## ArevaEPRDCPEm Resource

Attached is a DRAFT response for Question 07.01-35 of RAI No. 505 (FSAR Ch. 7) provided in the attached file in advance of the May 30, 2012 final date.

All indicated changes are in response to RAI 505, 07.01-35

Figure 2.6.9-2—Emergency Power Generating Building Ventilation System Functional Arrangement, Division 2

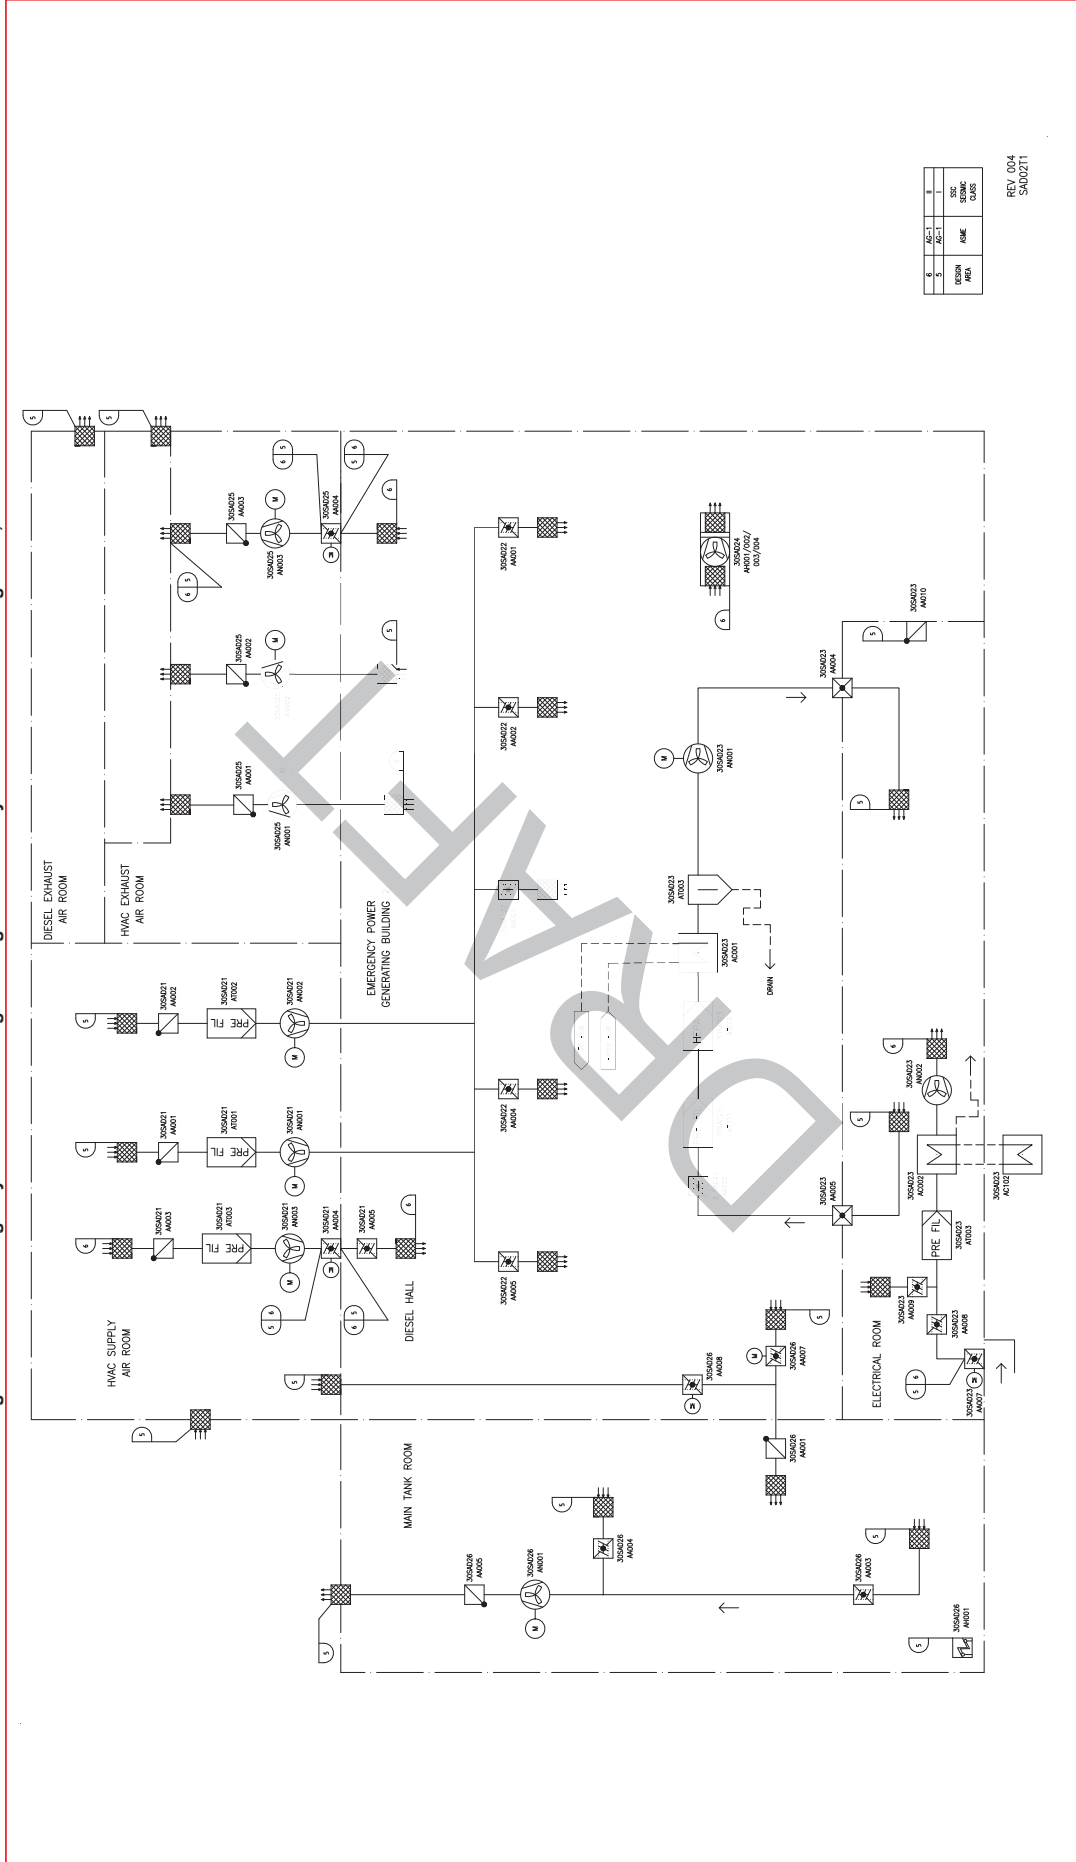
All indicated changes are in response to RAI 505, 07.01-35

Figure 2.6.9-4—Emergency Power Generating Building Ventilation System Functional Arrangement, Division 4

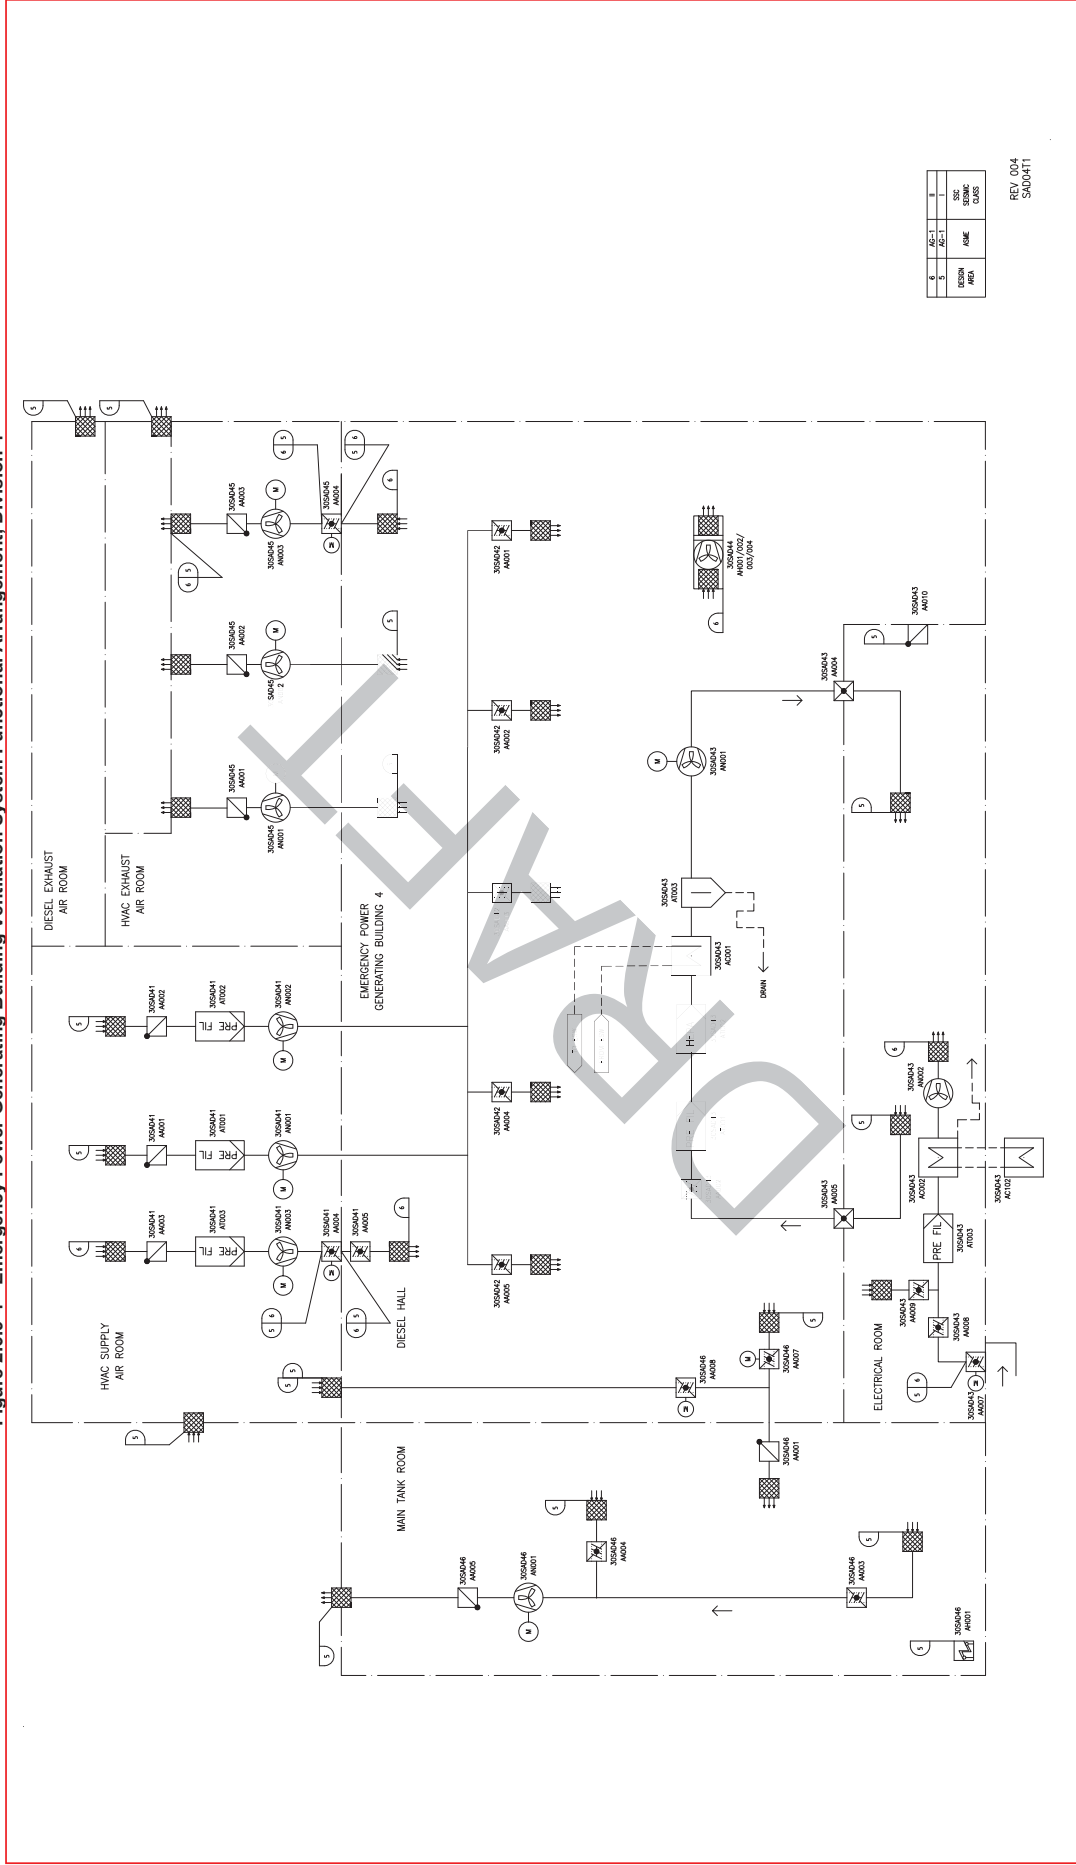
All indicated changes are in response to RAI 505, 07.01-35

Figure 2.6.13-1—Essential Service Water Pump Building Ventilation System Functional Arrangement

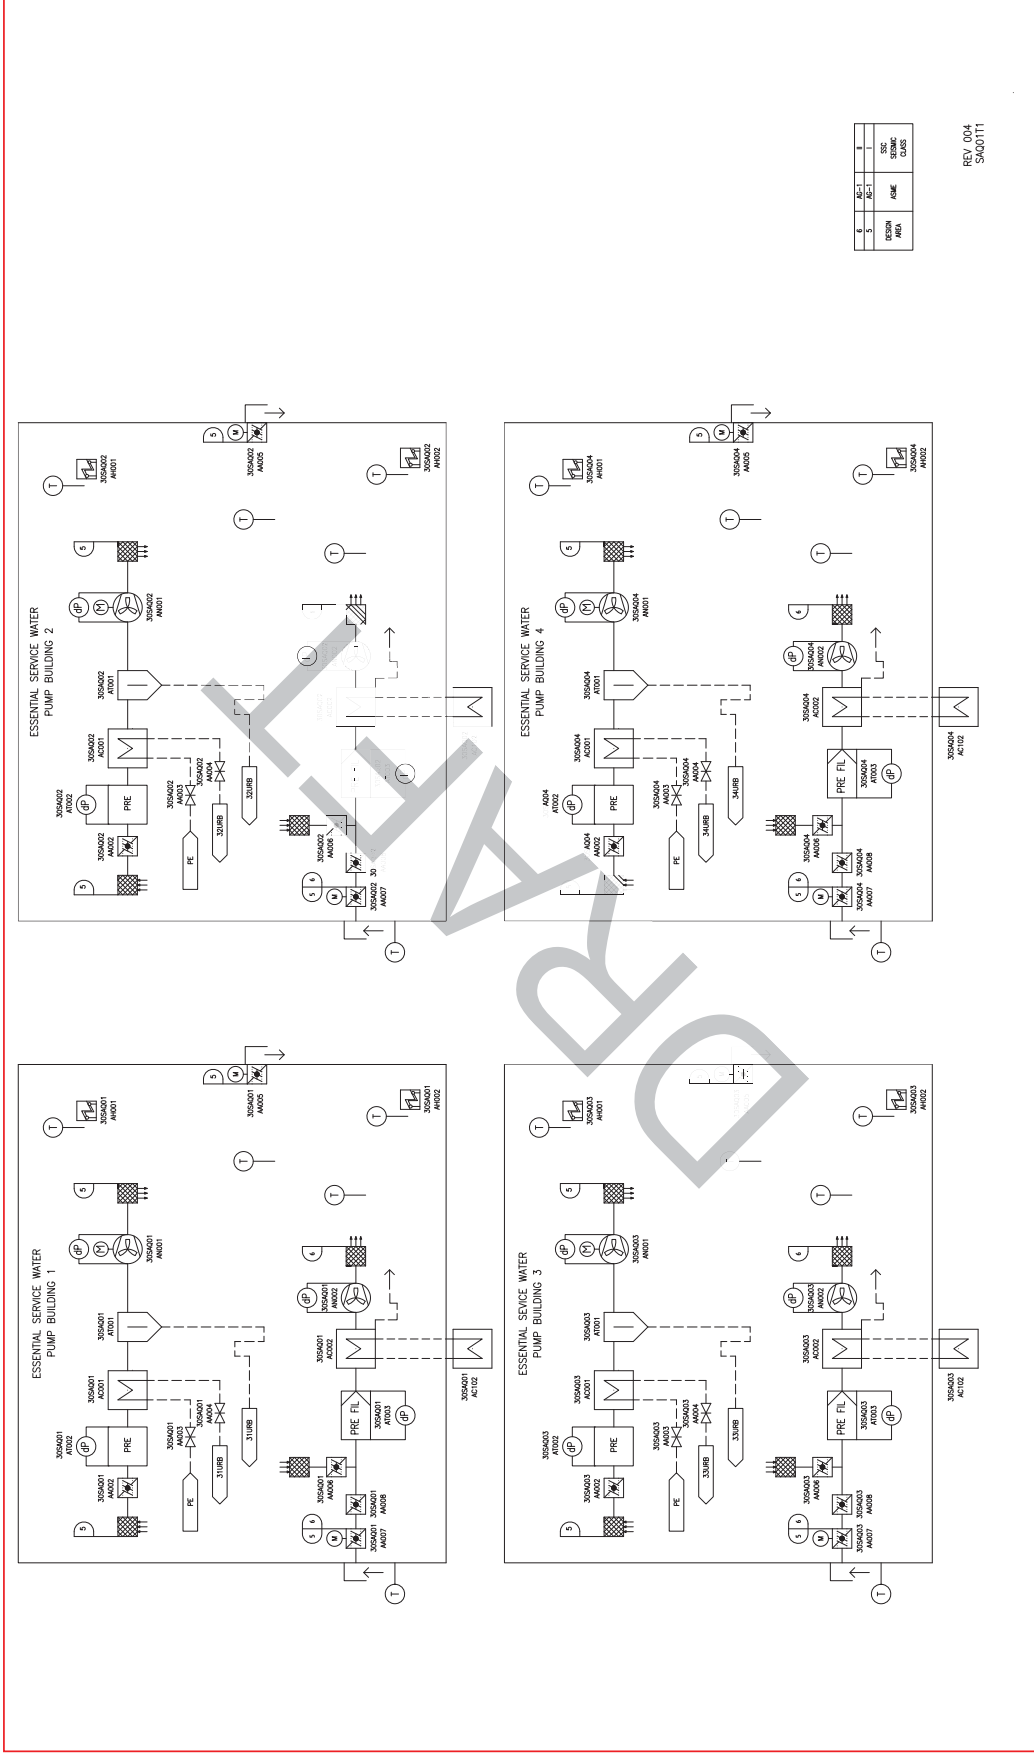
All indicated changes are in response to RAI 505, 07.01-35

**Figure 7.3-33—CCWS Common 1.b Automatic Backup Switchover of Train 1 to Train 2 and Train 2 to 1**

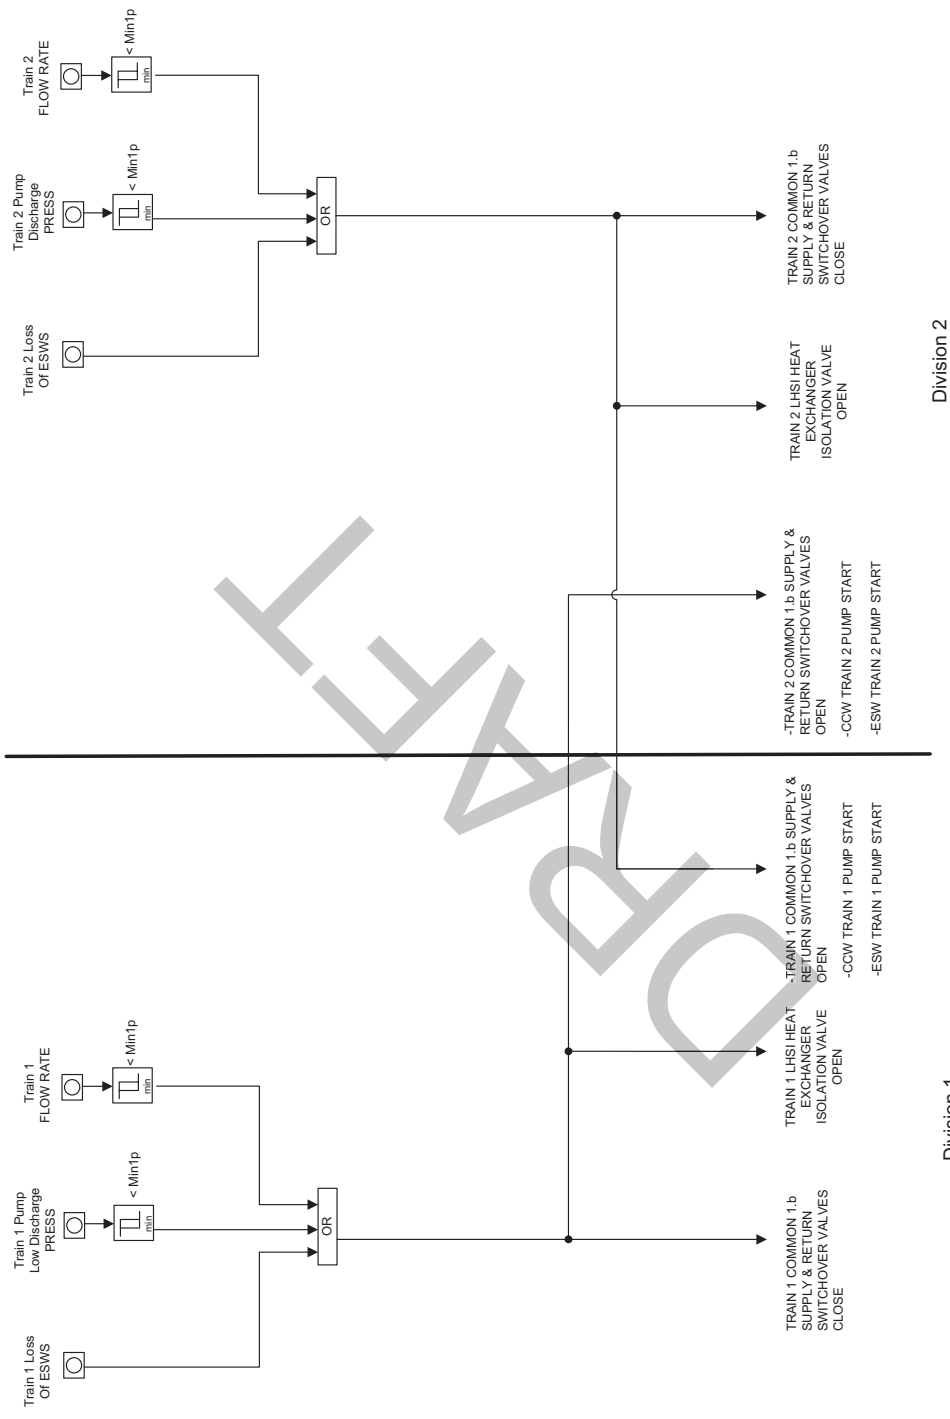
Component Cooling Water System (CCWS)	<del>CCWS</del> -Common 2.b Automatic Backup Switchover of Train 3 to Train 4. ( <u>Figure 7.3-33</u> )	<u>This function is described in Sections 7.3.1.4.1 and 9.2.2.</u> <del>The CCWS has a safety-related function to remove heat from safety-related components (GDC-44). The safety-related function to perform an automatic switchover from Train 3 to Train 4 verifies that the CCWS is capable of fulfilling its safety-related function to remove heat from safety-related components on the CCWS Common-2-a and 2-b.</del>	Similar to Train 1 to Train 2 Switchover, but for Train 3 to Train 4	Discrete	Vote	<del>The I&amp;G associated with the CCWS is described in Section 9.2.2.</del>

Figure 7.3-34—CCWS Emergency Temperature Control

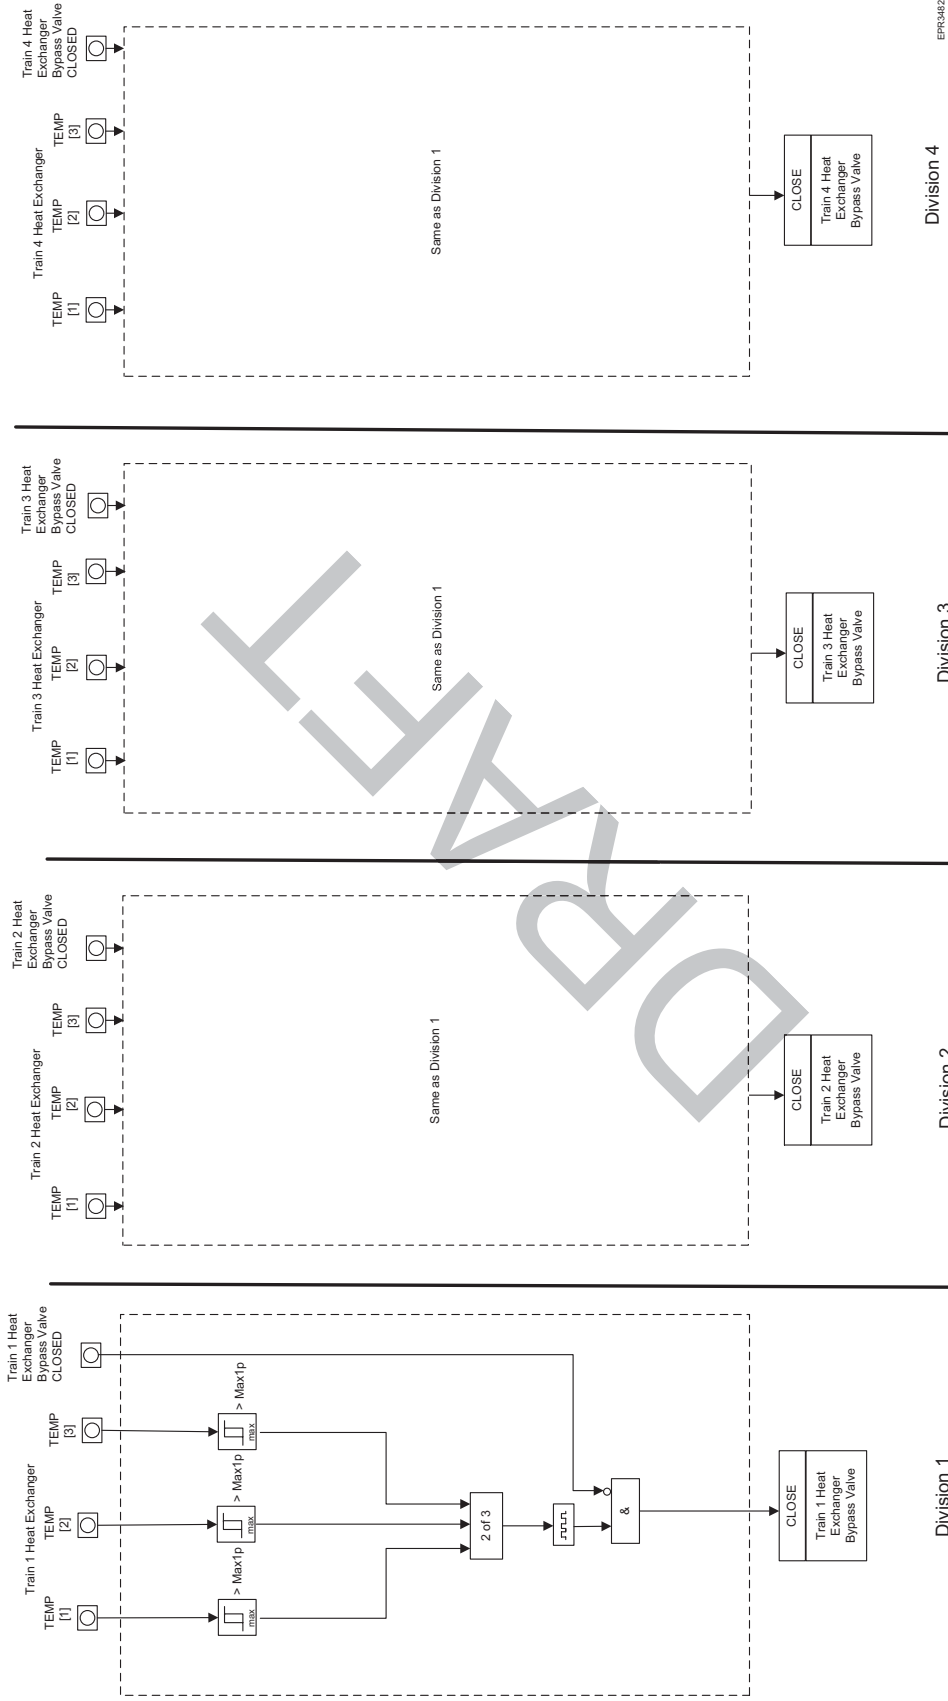
Component Cooling Water System (CCWS)	<del>CCWS</del> -Emergency Temperature Control ( <a href="#">Figure 7.3-34</a> )	<u>This function is described in Sections 7.3.1.4.1 and 9.2.2. The CCWS has a safety-related function to remove heat from safety-related components (GDC-44). The safety-related function to control the CCWS heat exchanger (HX) outlet temperature is required to maintain the temperature of the cooling water within its limits. This verifies that the CCWS is capable of fulfilling its safety-related function to remove heat from safety-related components.</u>	NO	N/A	N/A	<del>The I&amp;G associated with the CCWS is described in Section 9.2.2.</del>

All indicated changes are in response to RAI 505, 07.01-35

Figure 7.3-35—CCWS Emergency Leak Detection

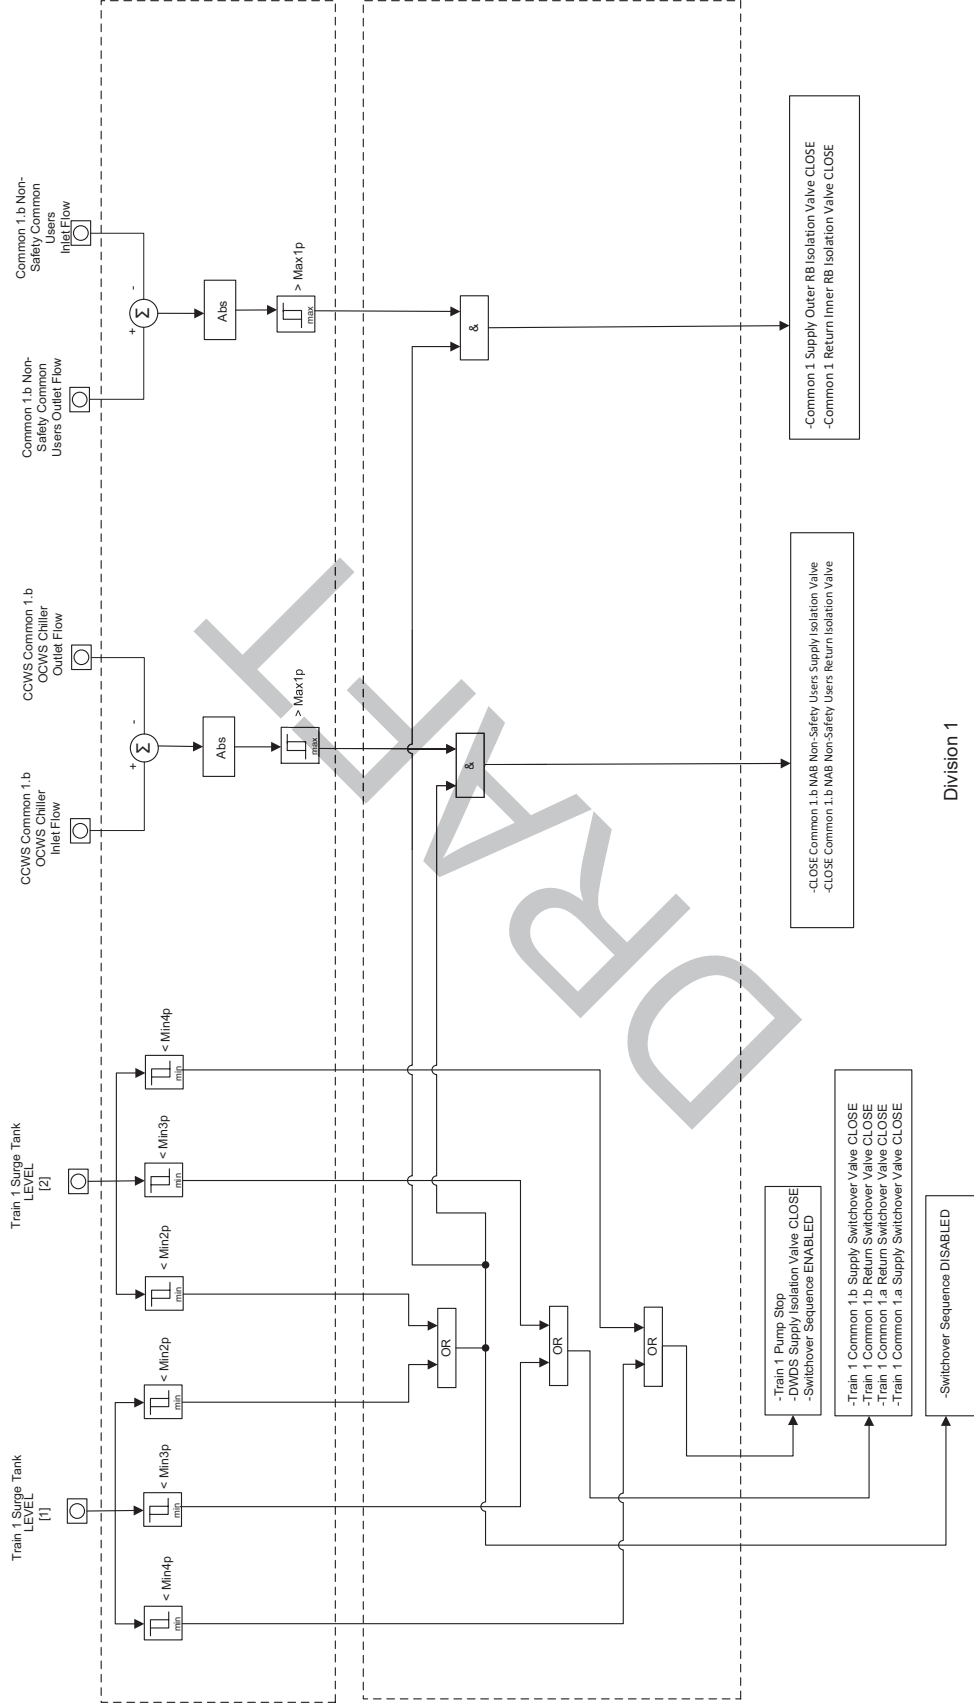
All indicated changes are in response to RAI 505, 07.01-35
